City of El Paso – City Plan Commission Staff Report

Case No: SUSC13-00001 Montecillo Unit Five
Application Type: Major Preliminary
CPC Hearing Date: May 2, 2013
Staff Planner: Nathaniel Baker, (915) 541-4192, bakernt@elpasotexas.gov
Location: East of Mesa Street and north of Argonaut Drive
Acreage: 16.6 acres
Rep District: 1
Existing Use: Undeveloped
Existing Zoning: SCZ (SmartCode)
Proposed Zoning: SCZ (SmartCode)
Nearest Park: Galatzan Park (1 mile)
Nearest School: Morehead Elementary (0.75 mile)
Park Fees Required: N/A
Impact Fee Area: N/A
Property Owner: EPT Montecillo Development East, L.P.
Applicant: Conde Inc.
Representative: Conde Inc.

ATTACHMENT 3

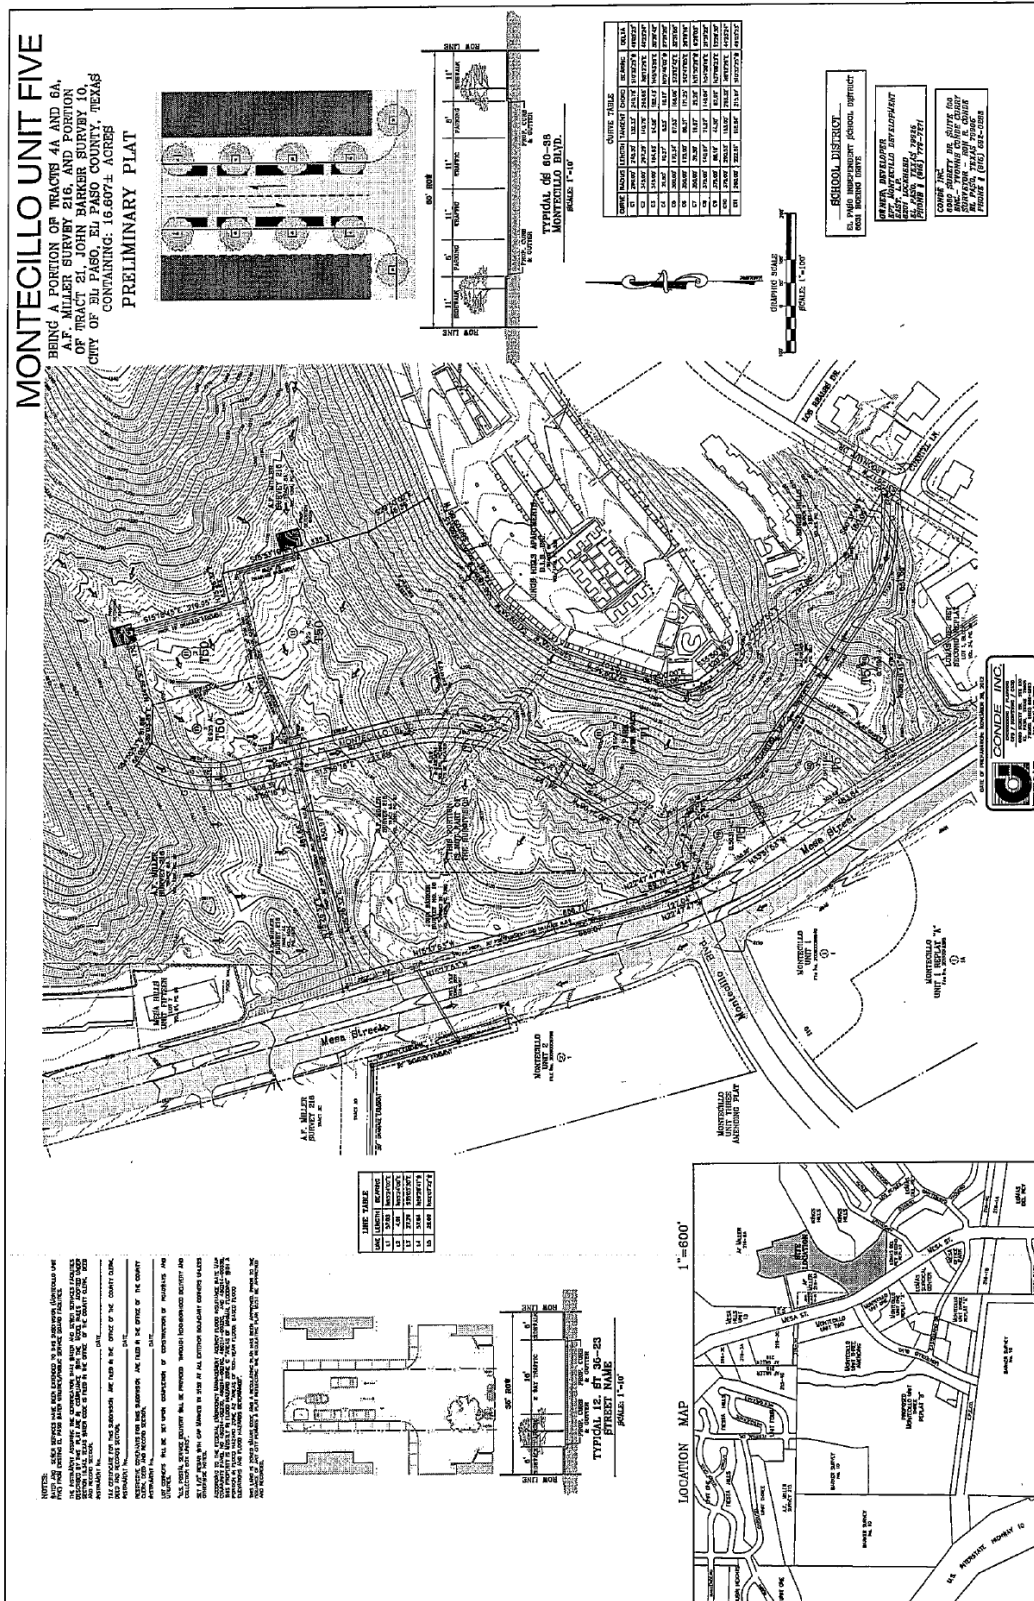
1. Lot widths for all lots, except the lot labeled as Lot 1, Block 10 on the Preliminary Building Scale Plan, are in excess of the 180 foot max. permitted by §21.80 Table 15D and 15E.
2. Cross-Section being shown for Montecillo Blvd. is CS 60-38, which does not match the cross-section shown in the approved Regulating Plan (i.e. ST 42-32). Additionally, it is not a pre-approved thoroughfare in the SmartCode and cannot be built from Tables 3A, 3B, 4A, and 4B included in §21.80. As a result, staff does not have the discretion to approve the proposed CS 60-38. As a possible solution, CS 60-34 is a pre-approved cross-section and is very similar to the proposed CS 60-38 (see §21.80 Table 4C); as a pre-approved cross-section, the Regulating Plan may be administratively adjusted to replace ST 42-32 with CS 60-34 (see §21.10.050(D)).

1. All developed storm water runoff must be retained within the subdivision boundaries.
2. TXDOT approval is required for access and drainage on Mesa Street.
3. Clarify Flood Zone designation.

1. The developer shall be responsible for maintenance of all offsite stormwater management facilities unless drainage easements or rights-of-way with adequate access are provided for the EPWU Stormwater Utility. Both proposed Detention Basins and a portion of storm sewer pipe are not within subdivision limits.
2. EPWU recommends using principles of low impact development (such as recessed landscaping, rainwater harvesting, and porous pavements) to reduce the amount of developed stormwater runoff.

1. Area designated as T1 does not meet the minimum acreage required of eight (8) acres.

2. The slopped areas are non-useable for un-structural recreation use and shall not be counted towards the required percentage of civic space.
3. Each designated T5 Transect Zone should have a "Public" meeting area & plazas.

4. Per site visit observations concrete flumes, drainage structures and surface flow storm water run-off is coming from the King Hills Apartments (southeast property) and running thru the area noted as "Park" (Open Space) area; clarify if drainage easements are to be proposed / required.

5. Provide drainage control from the King Hills apartments thru the area noted as "Park" (Open Space) area (Lot 1, Block 11) to avoid erosion of the face of the slopes.

6. Parks Department recommends for the area noted as "Park" (Open Space) area (Lot 1, Block 11) be labeled as Stormwater Open Space and the notation as "Park" be deleted.

7. Clarify ownership / purpose of the 10' R.O.W. & Easement (Vol. 366, Pg. 883) located with-in the area noted as "Park" (Open Space) area south of the King Hills Apartments, and clarify if to remain or be vacated by this plat.
